UNITED STATES PATENT AND TRADEMARK OFFICE

Office Action Summary	Application No. 10/563,338	Applicant(s) LAGLER, LOUIS	
	Examiner Daniel Tucker	Art Unit 4159

DETAILED ACTION

Fig. 1 of US Patent No. 5,148,912 (Nozawa hereinafter)

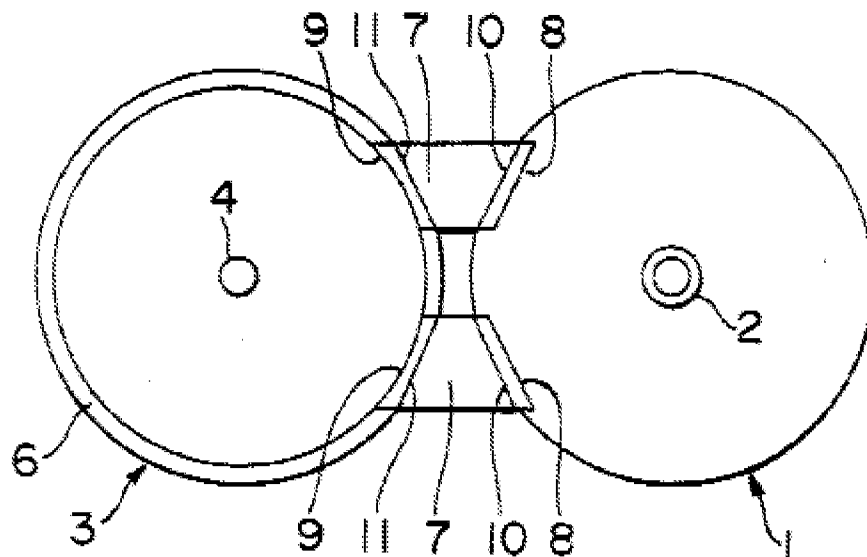
5. In re Claim 1, with reference to Fig. 1 and Fig. 4 above, Nozawa discloses:

- a body (1) comprising fixing (col. 7, lines 5-7) means to fix the closure on a neck of a bottle, and
- a lid (3), comprising a sealing mean (4) to seal an orifice (2) of the bottle,
- a snap hinge comprising a first and a second trapezoid element (7) and a first and second pair of film hinges (10, 11) each pair defining a first and a second plane (Fig. 4), the first and the second pair of film hinges (10, 11) connecting the first and the second trapezoid element (7) to the lid (3) and to the body (1), whereby the first and the second plane are arranged substantially parallel to an axis A (Fig. 4) of the closure.

Nozawa does not disclose that the body and the lid are separated by a circumferential gap.

11. In re Claim 5, with reference to Fig. 1 and Fig. 4 above, Nozawa discloses that that the film hinges (10, 11) are defined by a plane on the inside of the closure and the outside of the film hinges (10, 11) is defined by two flat boundary planes, arranged at an angle each other, and a cylindrical boundary surface having a radius.

12. In re Claim 6, with reference to Fig. 1 and Fig. 4 above, Nozawa discloses that the trapezoid elements (7) are spaced apart by a cutout.

15. In re Claim 10, with reference to Fig. 1 and Fig. 4 above, Nozawa discloses that the closure is characterized by a cylindrical outer wall section.

Fig. 5 of US Patent No. 6,041,477 (Rentsch et al. hereinafter)

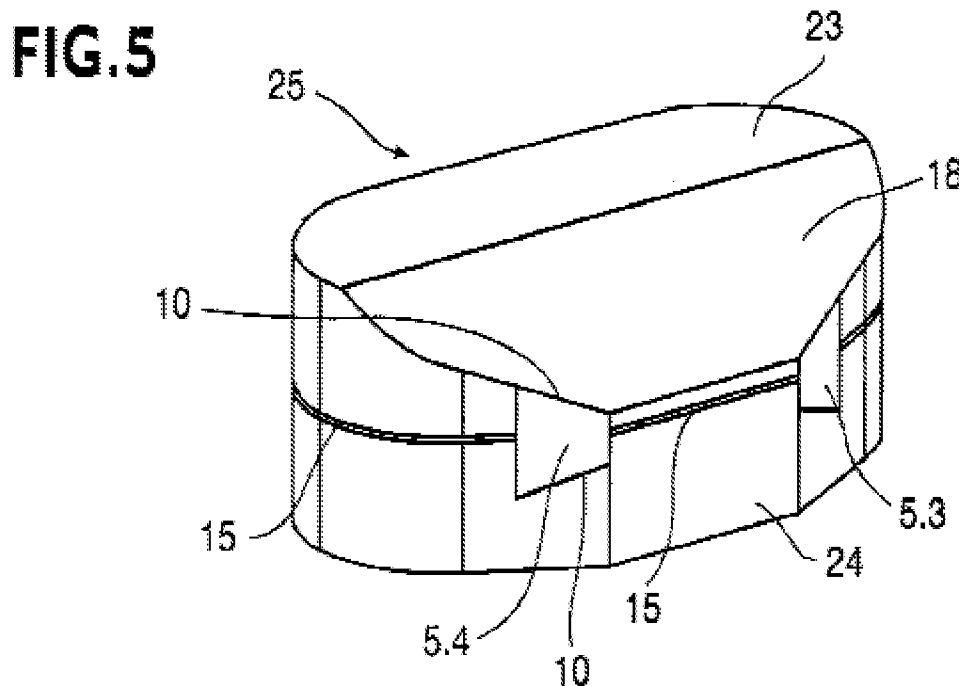
6. However, with reference to Fig. 5 above, Rentsch et al. discloses a closure whereby the body (24) and the lid (23) are separated from each other by a circumferential gap (15).

7. Thus it would have been obvious to one having ordinary skill in the pertinent art at the time the invention was made to have modified the closure of Nozawa to have a circumferential gap as taught by Rentsch et al. in order to achieve the predictable result of separating the body from the lid.

Fig. 7 of Rentsch et al.

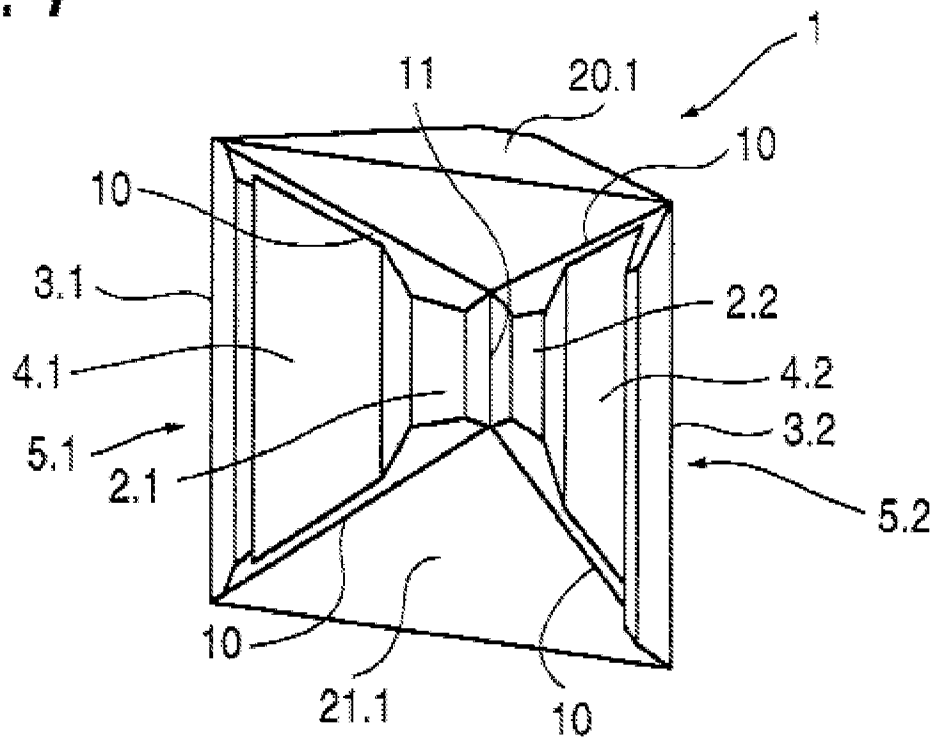
13. In re Claim 7, with reference to Fig. 7 above, Rentsch et al. discloses that the trapezoid elements (5.1, 5.2) are connected by a thin film hinge along a shorter edge (11).

Fig. 3 of US Patent Application Publication No. 2002/0079282A1 (Harrold et al. hereinafter)

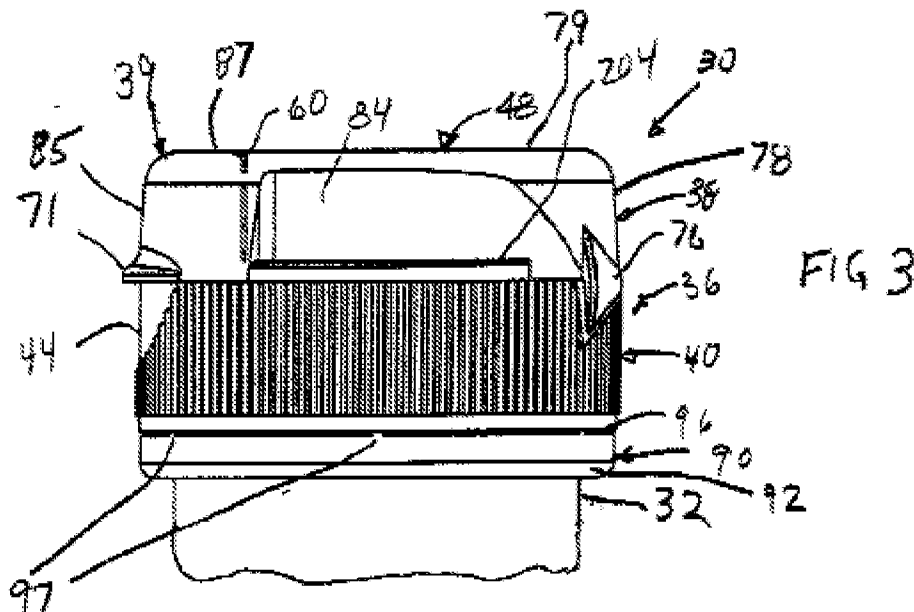
18. However, with reference to Fig. 3 above, Harrold et al. discloses tamper evidence means (90).

19. Thus, it would have been obvious to one having ordinary skill in the pertinent art at the time the invention was made to have modified the closure disclosed by Nozawa in view of Rentsch et al. to have tamper evidence means as taught by Harrold et al. in order to achieve the predictable result of indicating if the closure had been tampered with.
